SANTEE COMMUNITY CENTER
CIP 2018-31

ADDENDUM NO. 1

This Addendum No. 1 (132 pages in total) forms an essential part of the contract documents by revising the following:

3 / S0.52 TYPICAL WALL SUPPORTED EXTERIOR METAL STUD CEILING DETAIL
NOT TO SCALE

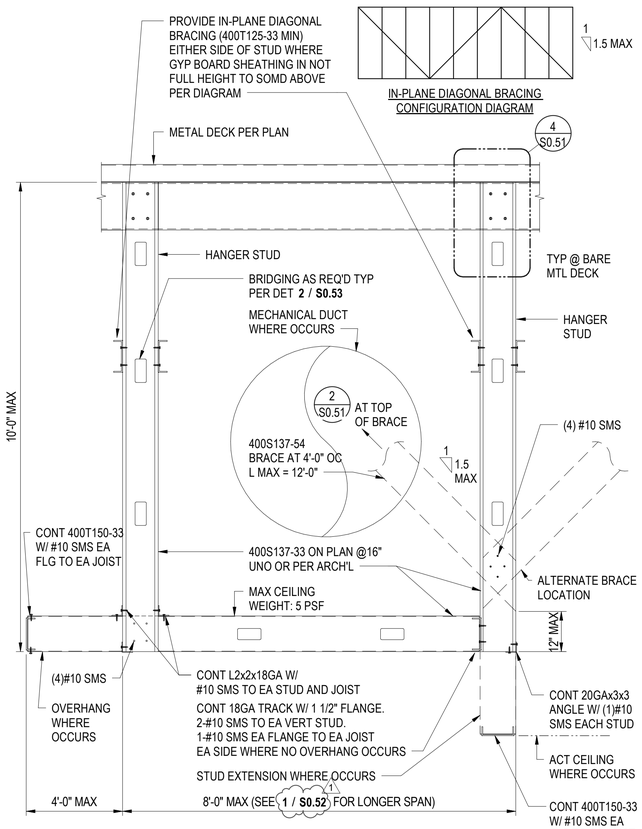
1C-13 Drawing Sheet **S0.51 TYPICAL METAL STUD DETAILS**
- a. Revised detail 3 references for clarification.

4 / S0.91 TYPICAL MECHANICAL SCREEN WALL SUPPORT DETAIL
NOT TO SCALE

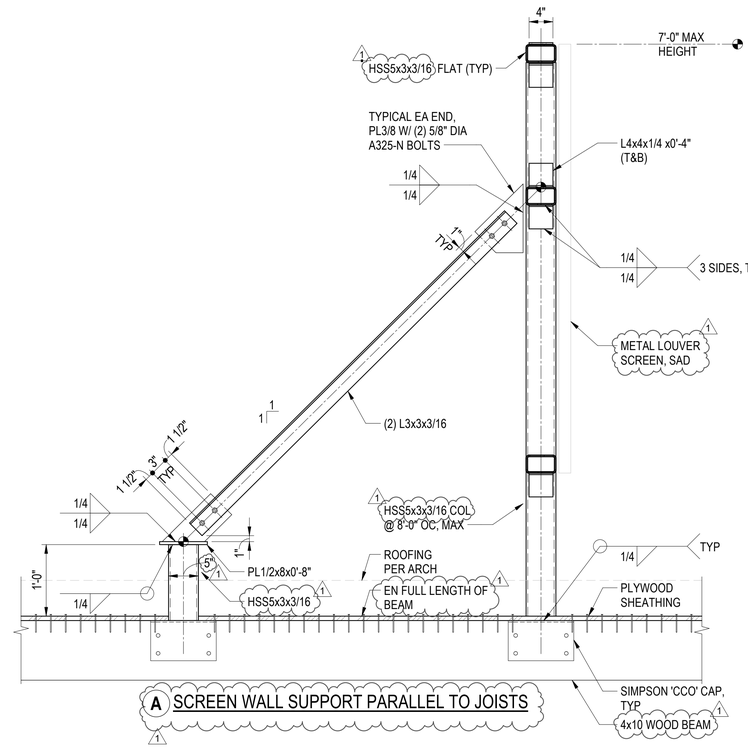
1C-19 Drawing Sheet **S0.91 MISCELLANEOUS DETAILS**
- a. Revised detail 4.

3 / S0.93 HANGER ROD DETAIL
NOT TO SCALE

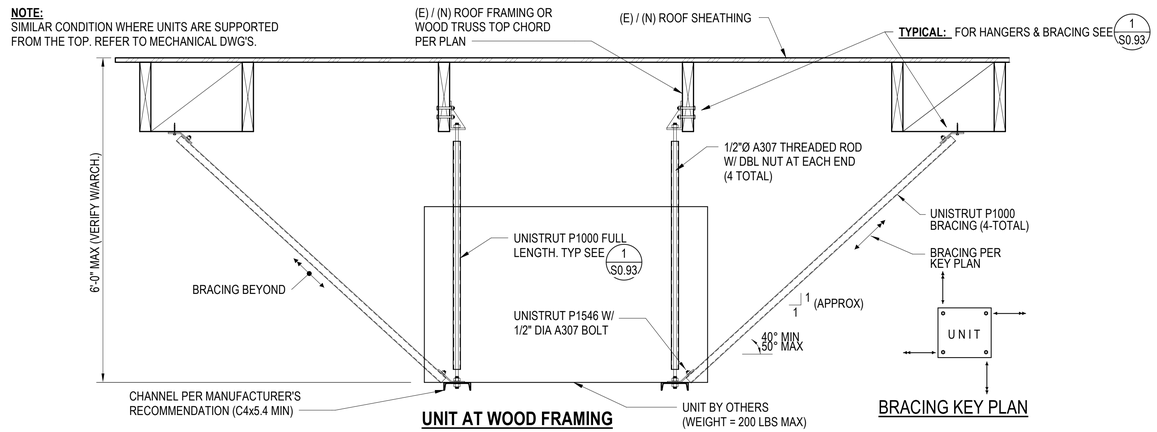
1C-21 Drawing Sheet **S0.93 MISCELLANEOUS DETAILS**
- a. Revised detail 3 for clarity.

3D ISOMETRIC VIEWS -1

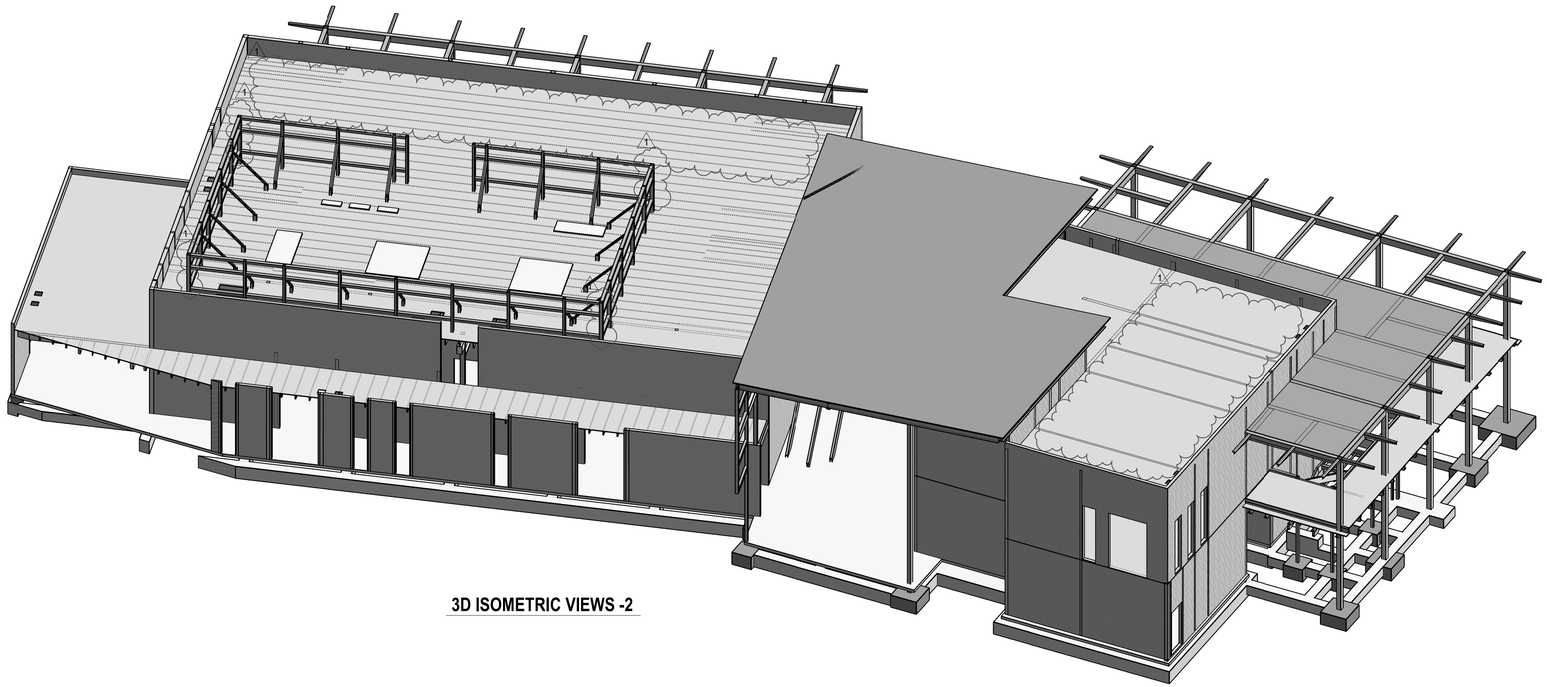
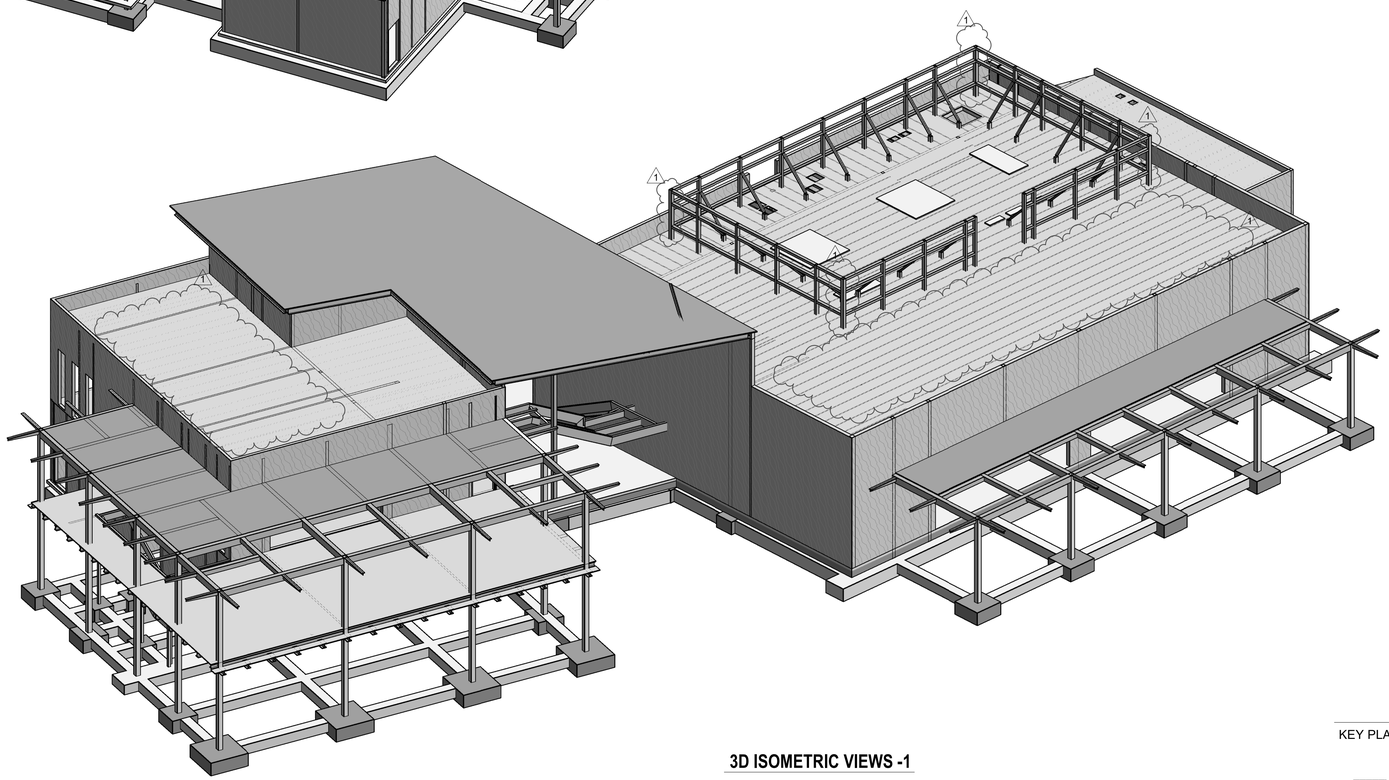
1C-22 Drawing Sheet **S1.01 3D ISOMETRIC VIEWS**
- a. Removed PV supports.

1D-16 Question: In the Architecturals it shows solar. On S1.01 shows Solar Stanchions with Rails. No other details in the structurals shows solar stanchions. Will Solar Stanchions be installed as part of these plans? If so, please provide.

Response: The stanchions shown on S1.01 were a graphical error and have been removed in Addendum 1.

1 S3.03 ENLARGED FOUNDATION PLAN
3/8" = 1'-0"

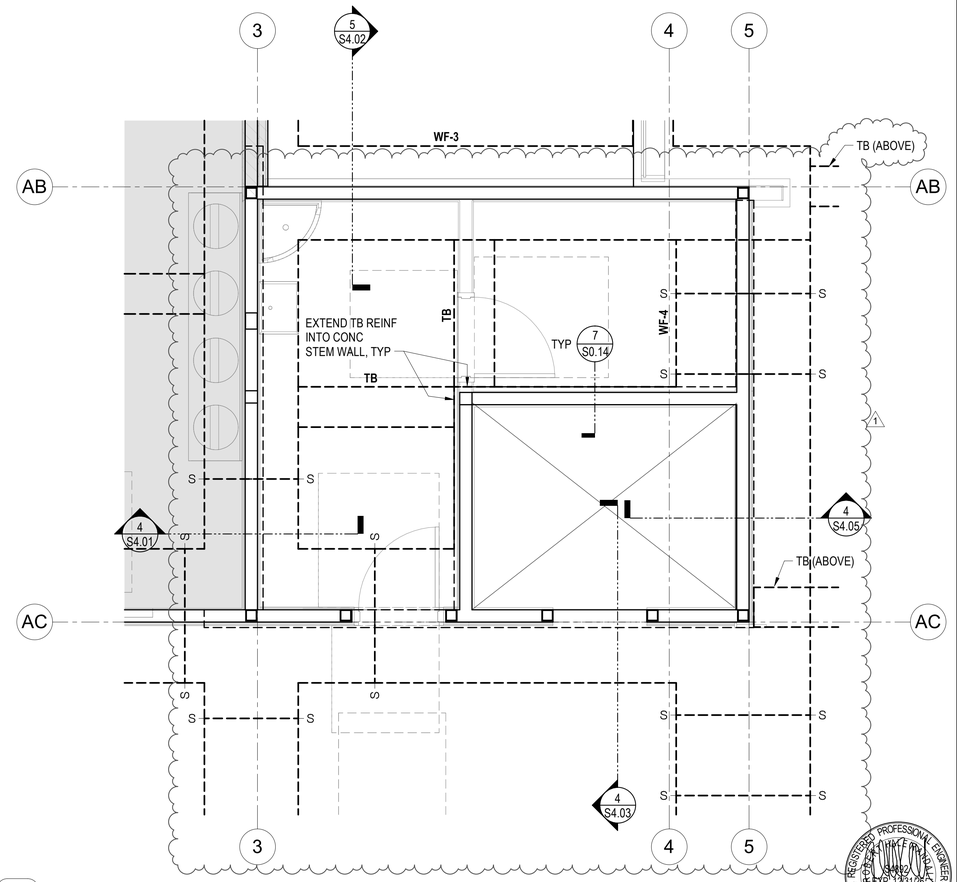
1C-35 Drawing Sheet **S3.03 ENLARGED FOUNDATION PLAN AND SECTIONS**
- a. Removed mat foundation and added wall footings in elevator pit area.

1 S4.01 WALL SECTION 1/2" = 1'-0"

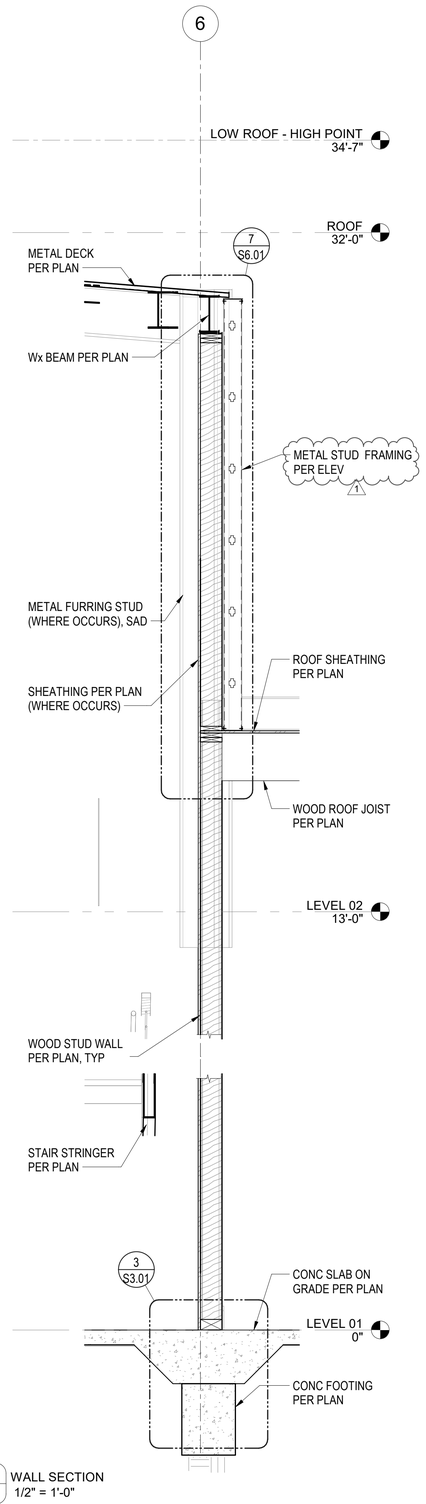
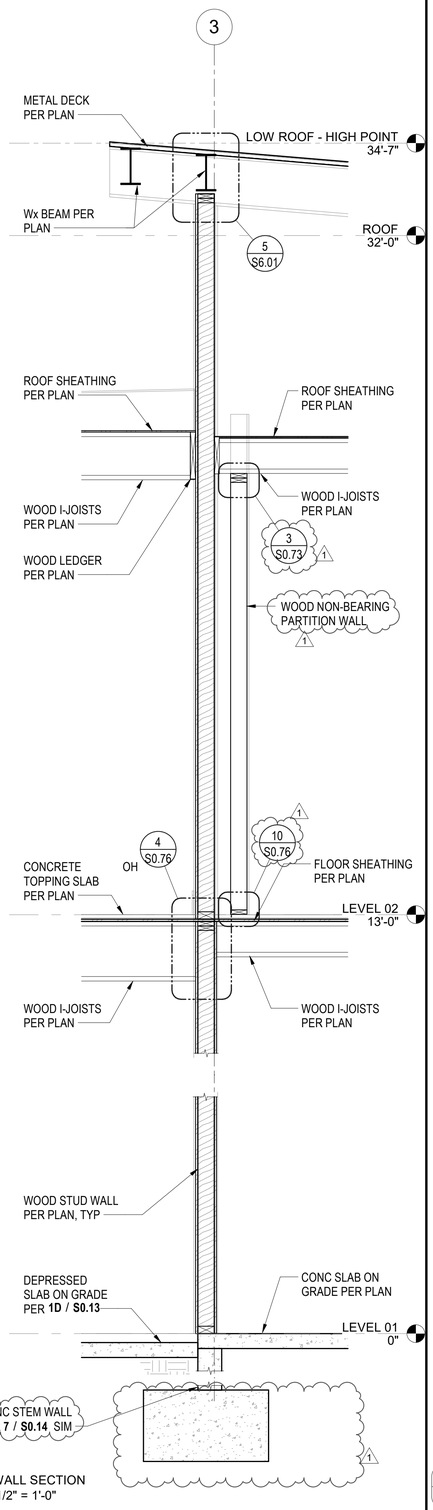
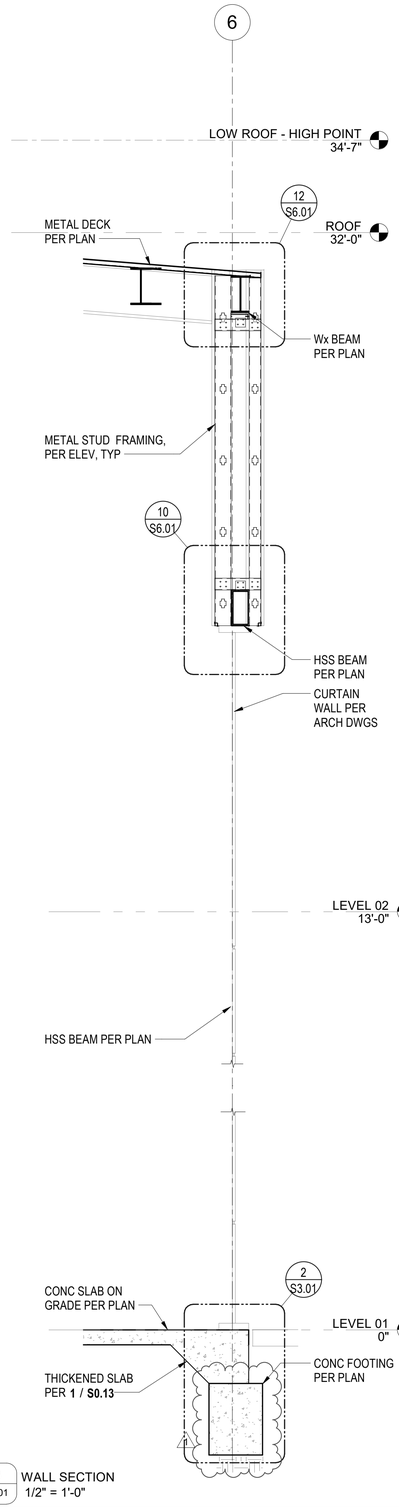
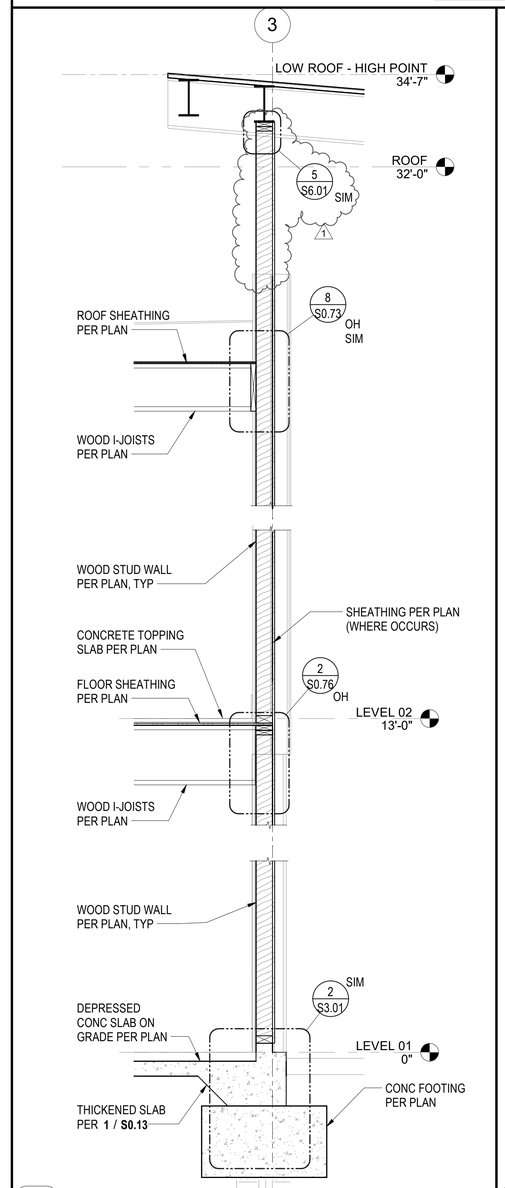
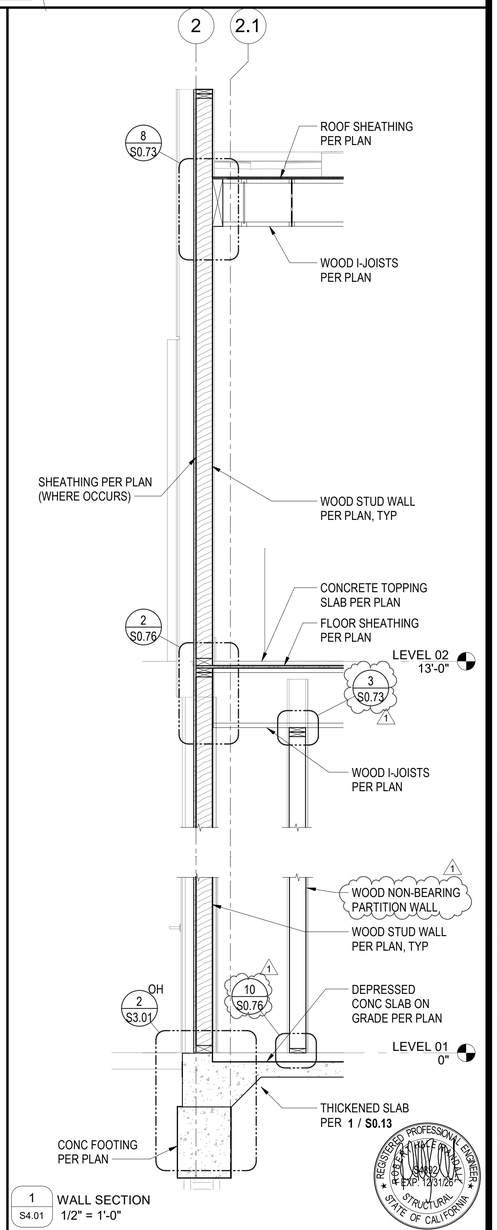
1C-36 Drawing Sheet **S4.01 WALL SECTIONS**
- a. Revised sections 1, 2, 3, 4, and 5.

2 S4.02 WALL SECTION 1/2" = 1'-0"

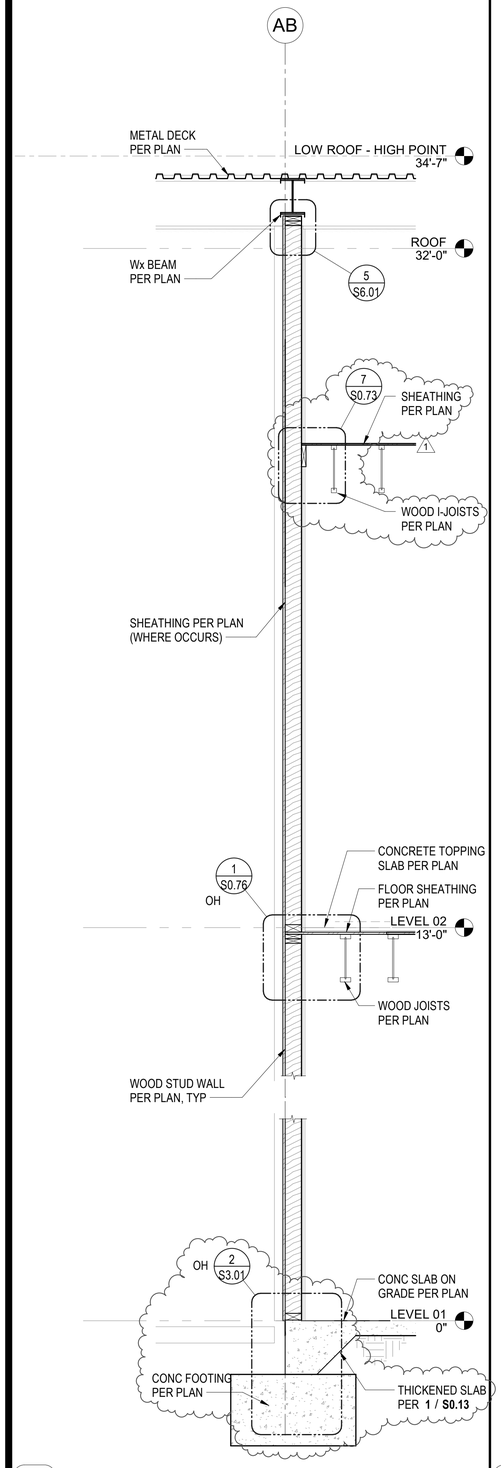
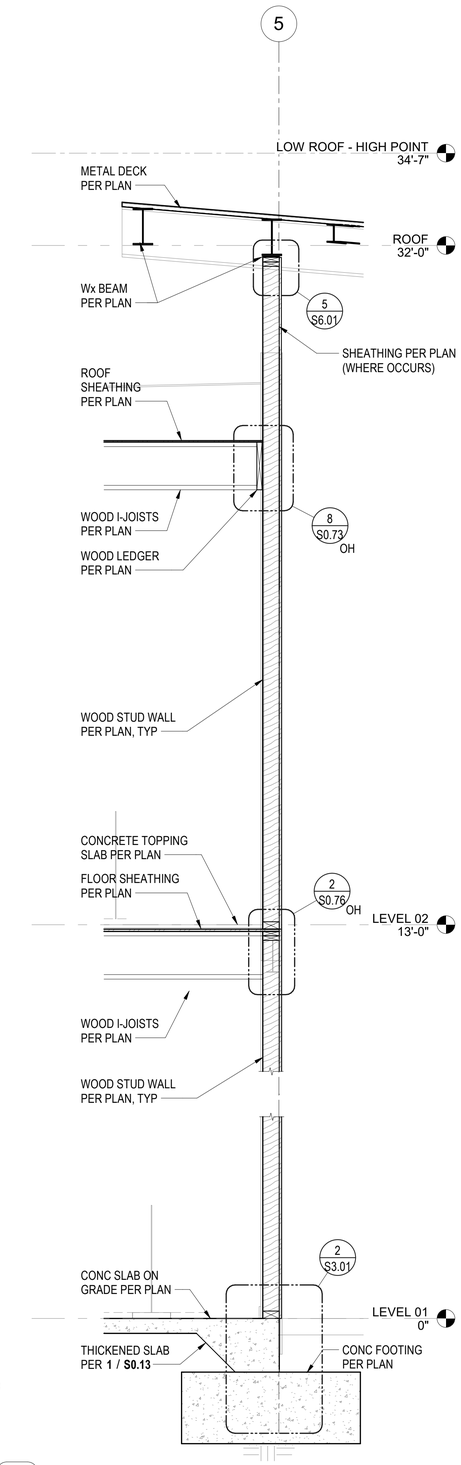
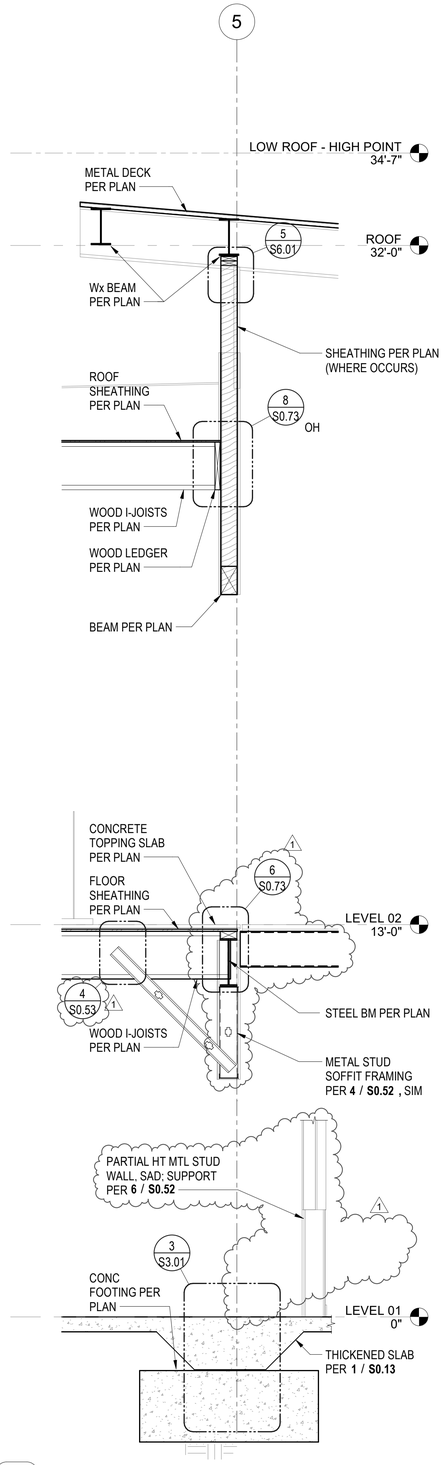
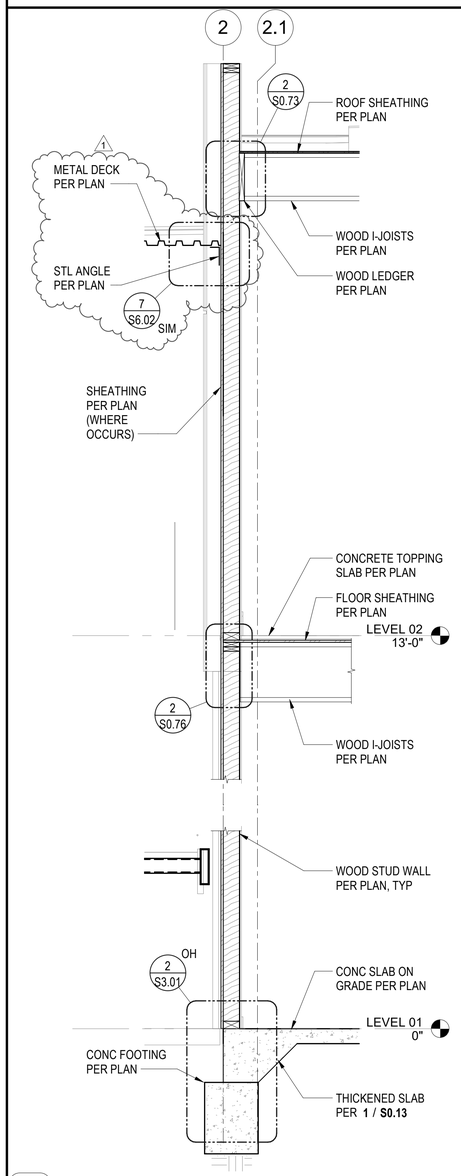
1C-37 Drawing Sheet **S4.02 WALL SECTIONS**
- a. Added deck angle to section 2.
- b. Revised section 3.
- c. Minor graphic revisions to section 4.
